Subject: Responses to Staff Comments and Questions on Telecommunications Needs Analysis and Visual Impact Assessment for DP 5050-B

RE: Responses to LUPC Comments on development application for Dallas Plantation Telecommunications Facility

2. Clarify the basis for rating the level of significance for Rangeley Lake and Rangeley Lake State Park (see comment 3,a,i-ii).

VIEWPOINT 1: Rangeley Lake State Park

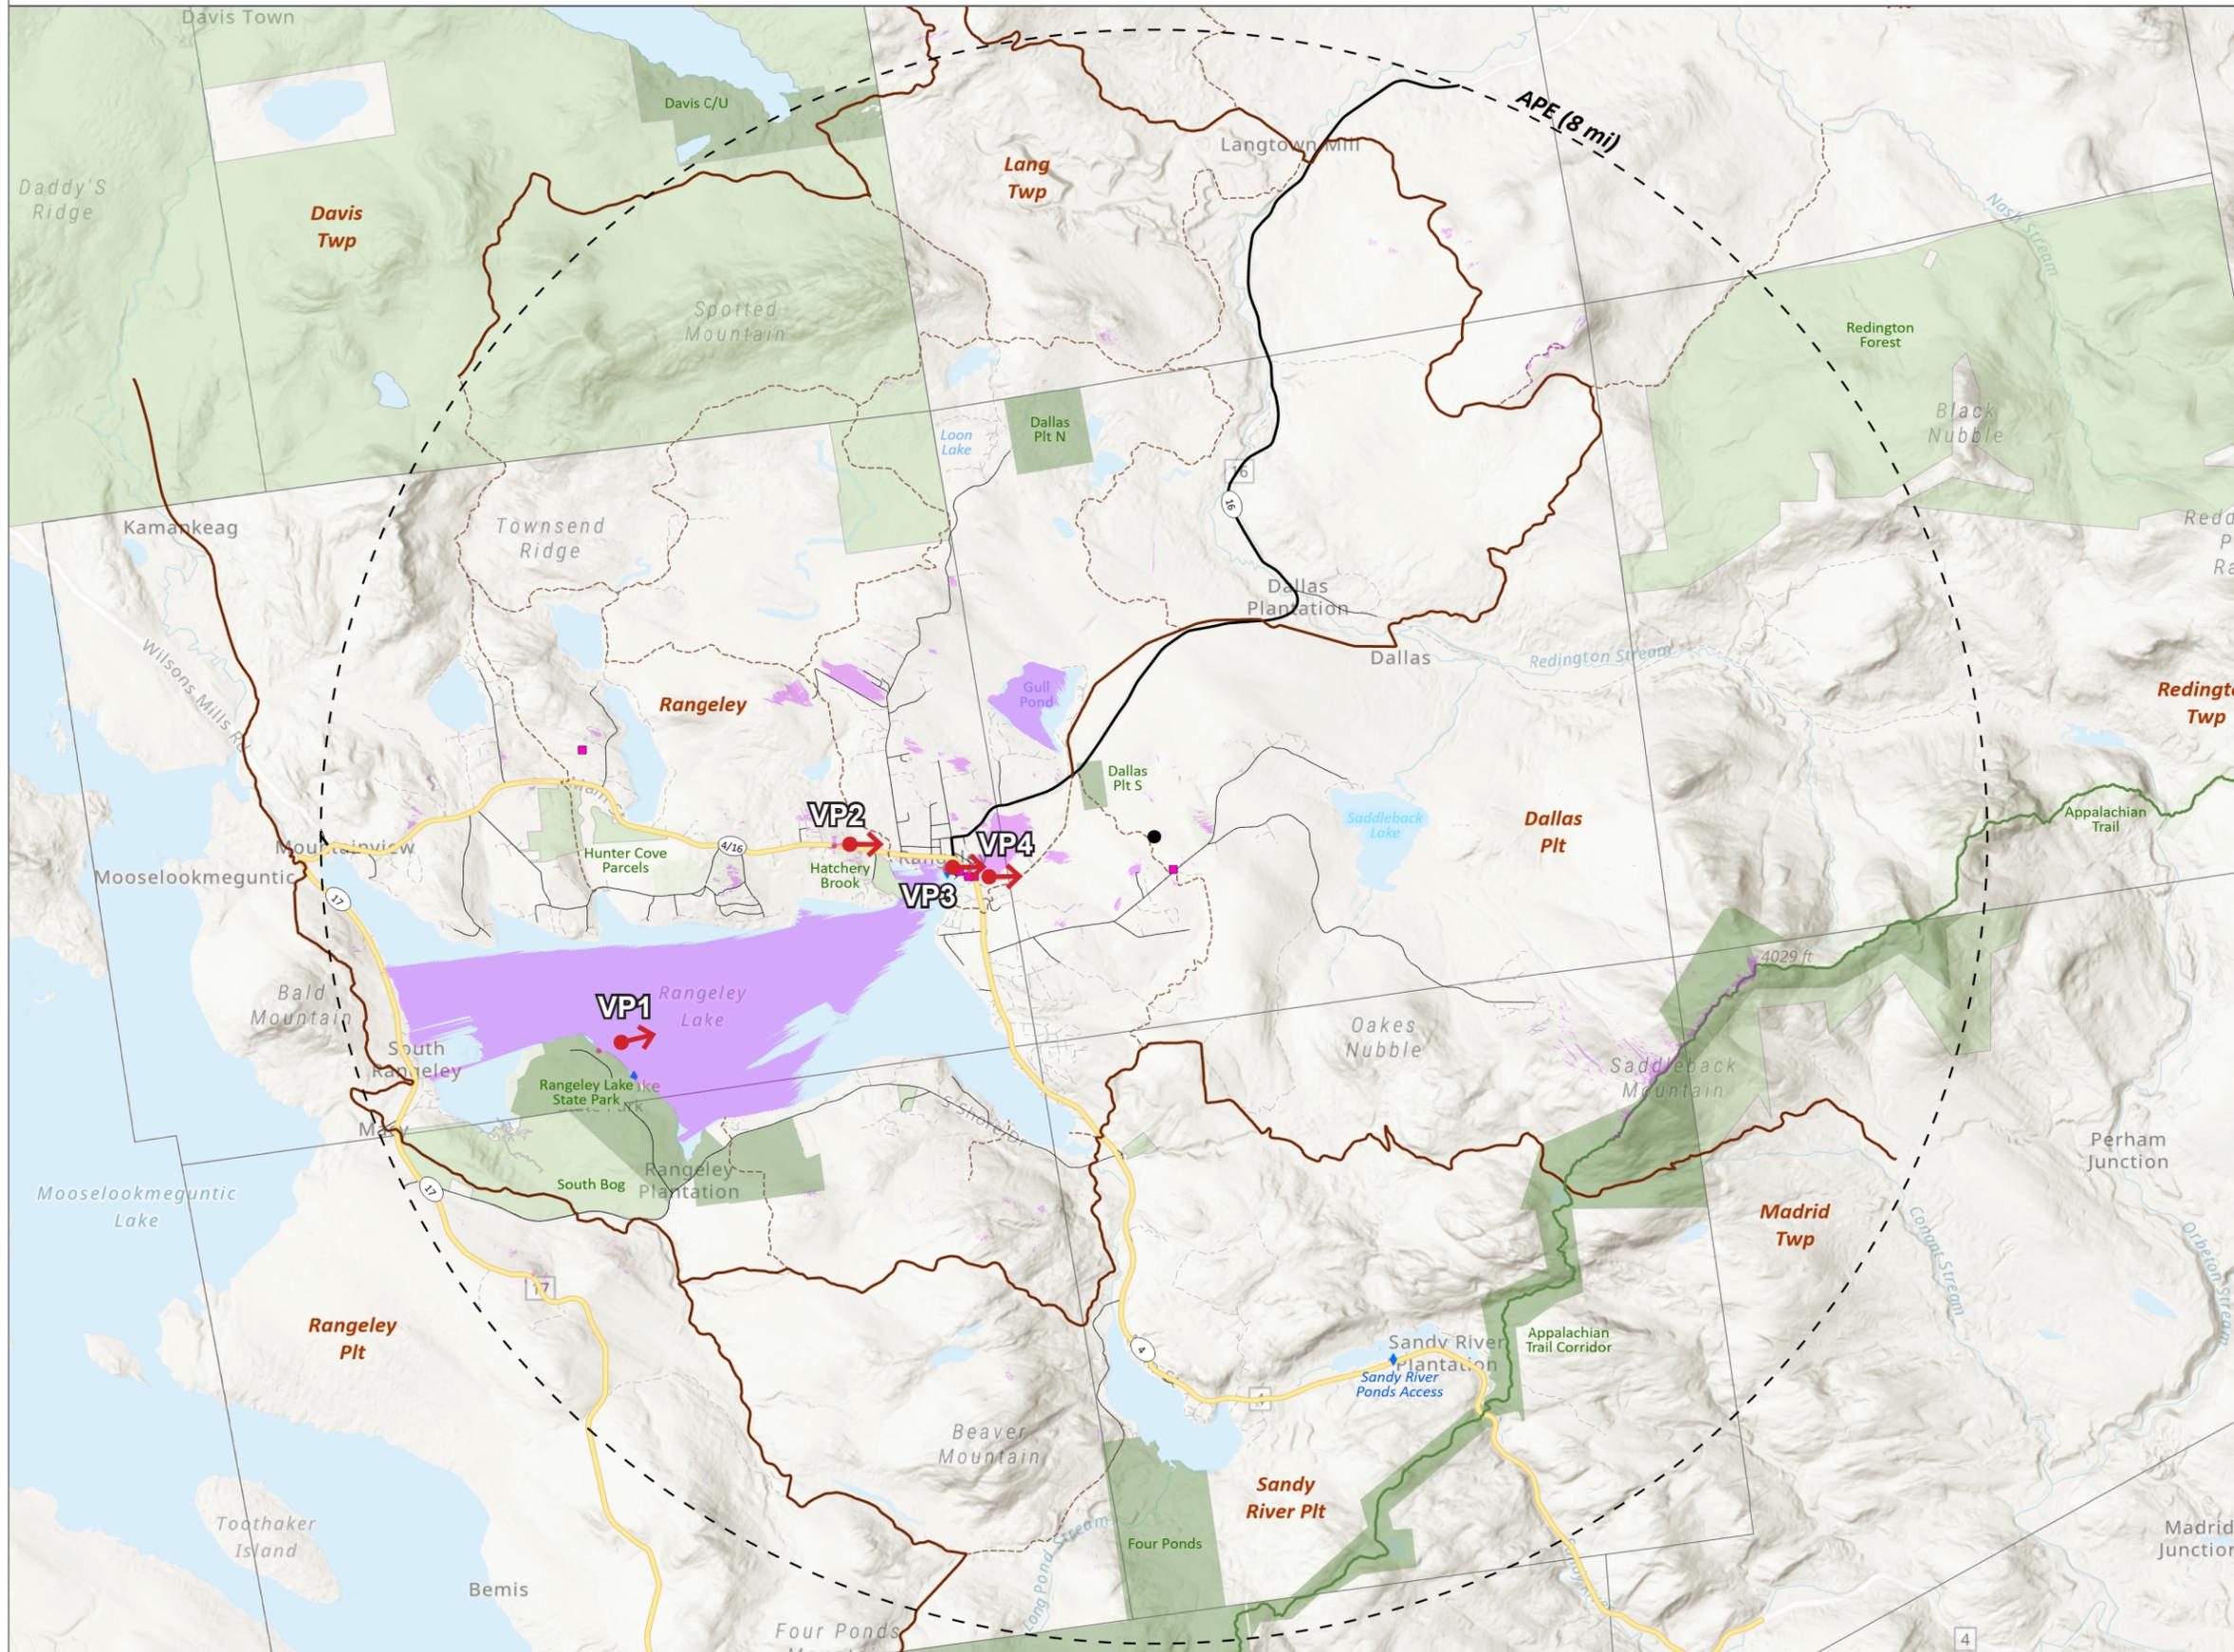
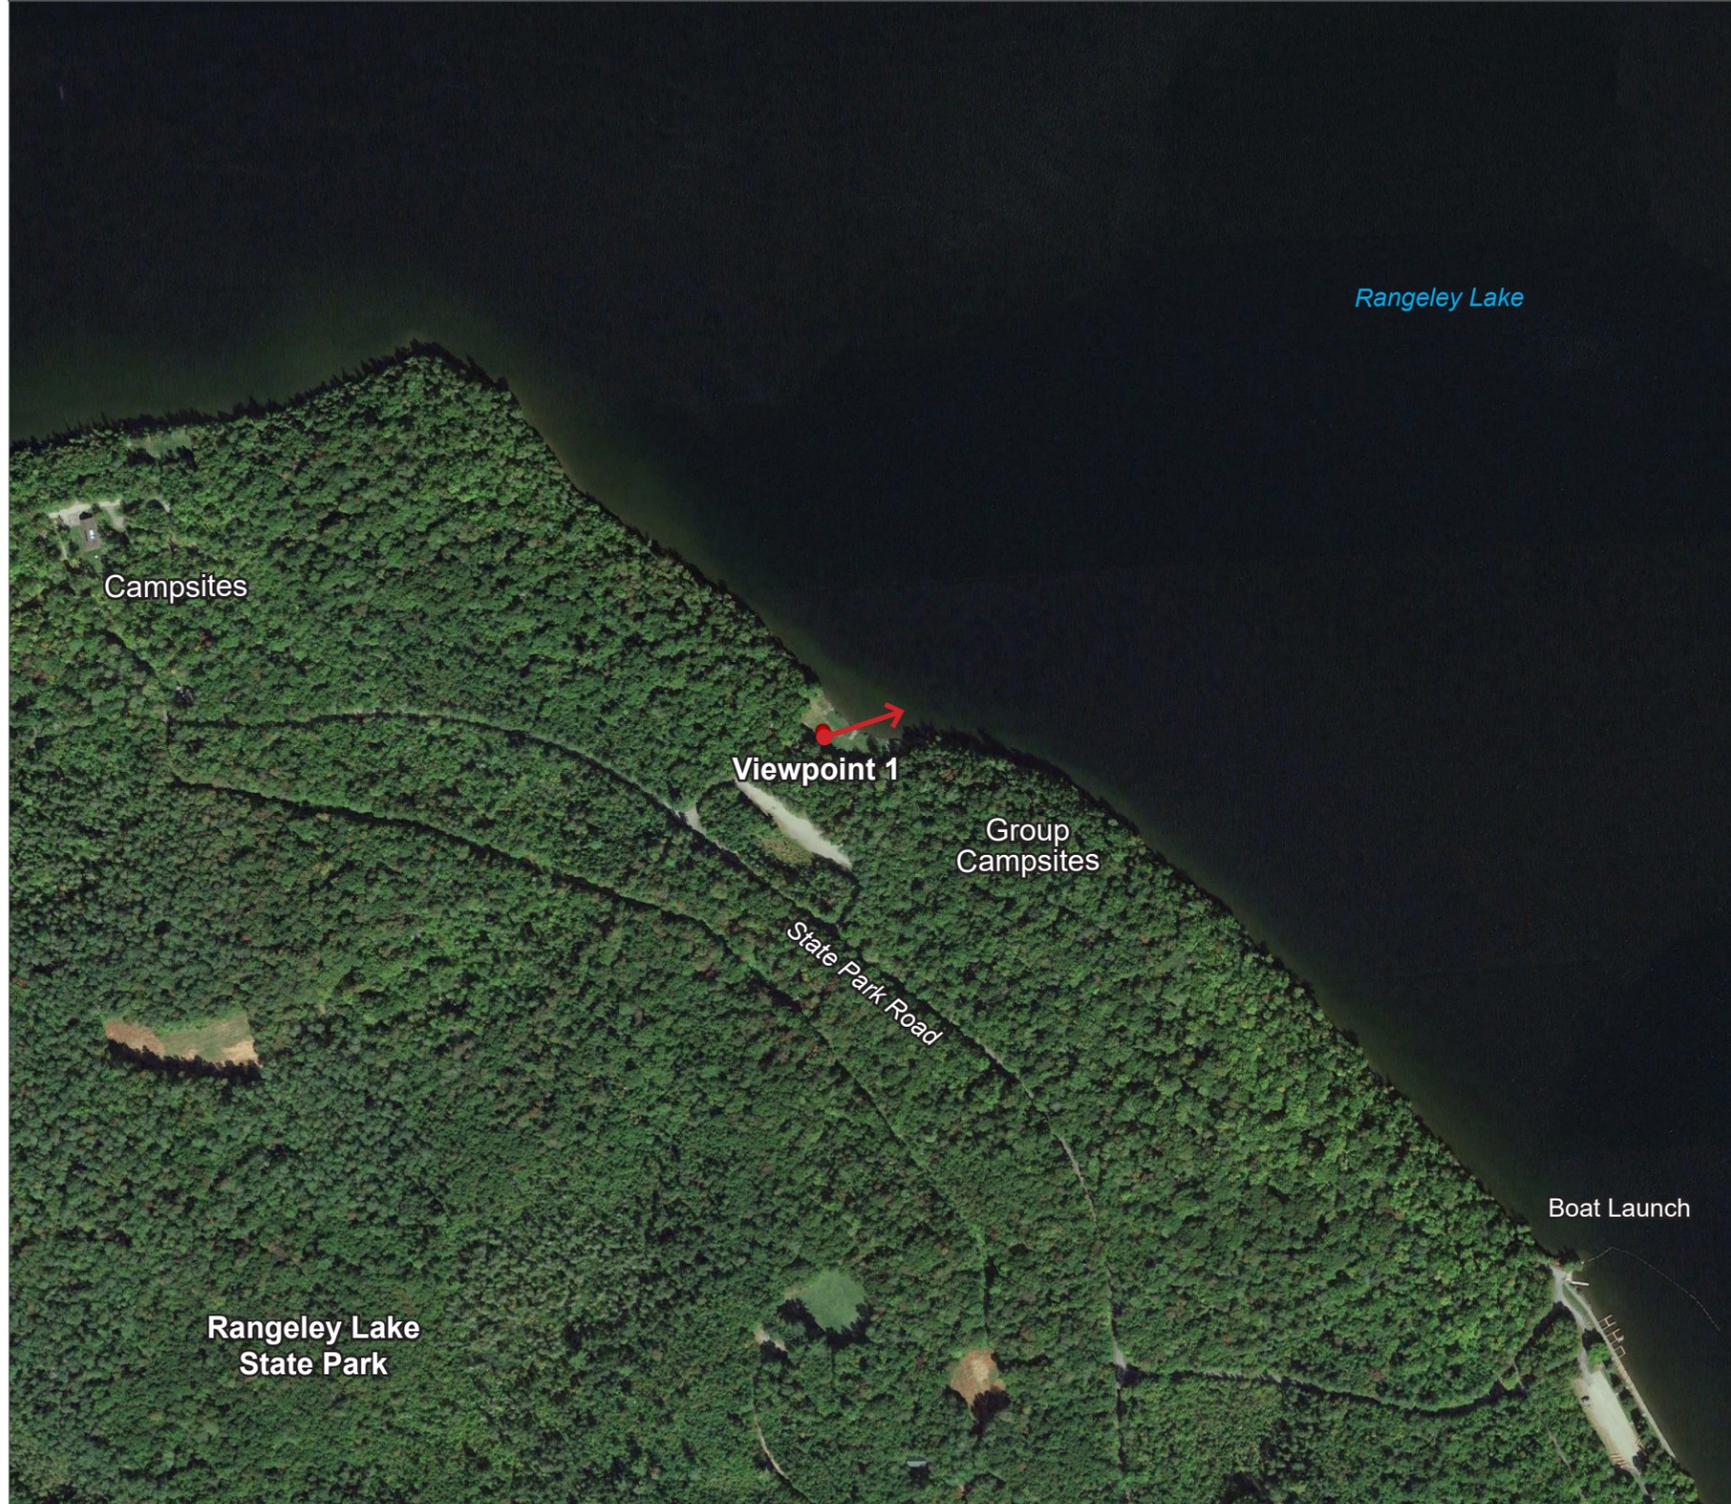
6. Provide nighttime photo simulations for views from campsites and the public beach area at Rangeley Lake State Park (see comment 3,b,ii).

Based upon field visits by TJD&A, there are no open views of the proposed tower from campsites within Rangeley Lake State Park. The tower will be located to the east at a distance of 5.7 miles. As noted on the campground map below, the main campground (and playground) has water on the north side. Individual sites are generally set back from the edge of the water with only occasional filtered views of the lake.

There are group sites on either side of the beach which do face east. However, these sites are also very well screened and set back from the edge of the lake.

The public beach, on the other hand, looks directly at the mountains, Rangeley Village, and the site of the proposed tower (See Visual Simulations, Viewpoint 1: Rangeley Lake State Park in Attachment B). The visual impact of the FAA lighting on the State Park should consider a number of mitigating factors:

- The telecommunications tower lighting will be in context with streetlights, vehicle headlights, and lit buildings in the village. There are two major differences, however. Unlike the existing village lights, the FAA light is red (unlike the white existing lights) and it flashes 30± times per minute.
- Viewers at the beach already see one other communications tower with FAA lighting on the north side of Rangeley Lake on Route 4. This tower is approximately 3.0 miles from the beach, so its intensity should be somewhat greater than the proposed tower.
- According to the gatekeeper at the State Park, there is virtually no use of the beach or the boat launch after dark. This may be due to the lack of lighting at these facilities, the nature of camping in general, and/or the presence of mosquitoes and other insects that appear after sunset.
